# UNITED STATES PATENT AND TRADEMARK OFFICE

APPLICATION NO.	FILING DATE	FIRST NAMED INVENTOR	ATTORNEY DOCKET NO.	CONFIRMATION NO.
10/774,739	02/09/2004	Dean A. Schaefer	1001.1386102	9215
28075	7590	05/14/2009	EXAMINER	
CROMPTON, SEAGER & TUFTE, LLC 1221 NICOLLET AVENUE SUITE 800 MINNEAPOLIS, MN 55403-2420			VU, QUYNH-NHU HOANG	
			ART UNIT	PAPER NUMBER
			3763	
			MAIL DATE	DELIVERY MODE
			05/14/2009	PAPER

**Office Action Summary**

**DETAILED ACTION*****Response to Amendment***

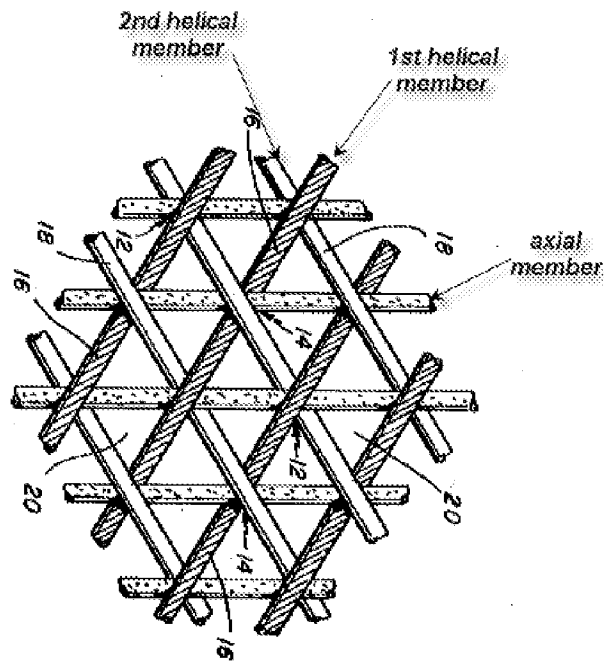
Kaye discloses the fabric interwoven cross construction comprises a first and a second member 16, 18 forming a plurality of crossover point, and a plurality of axial members disposed between the first and second member at each of the plurality of crossover point.

It would have been obvious at the time the invention was made to a person having ordinary skill in the art to modify the device of Webster with a interwoven cross construction, as taught by Kay, in order to prevent slippage, maximize tear resistance, high torsional stiffness, high resiliency and high flexibility.

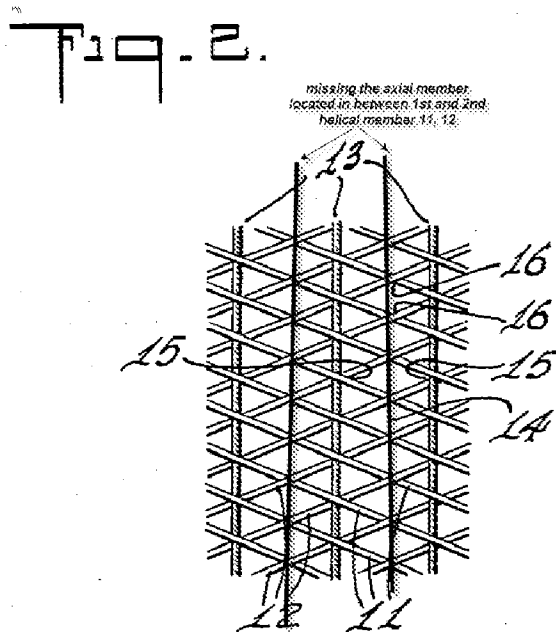
Huppert discloses that device comprising an elongated shaft having a reinforcement/braid layer comprising a tubular braid having a first and second helical member 11, 12 and plurality of axial members 13 disposed between the first and second helical member at some of the plurality of crossover points but not at each of the plurality of crossover points as in claim 16. In other words, there is missing of some of axial members located in between the first and second members as shown in Fig. 2 below.

It would have been an obvious to one of ordinary skill in the art at the time the invention was made to add more axial member for the purpose of increasing the reinforcing or torsional rigidity.
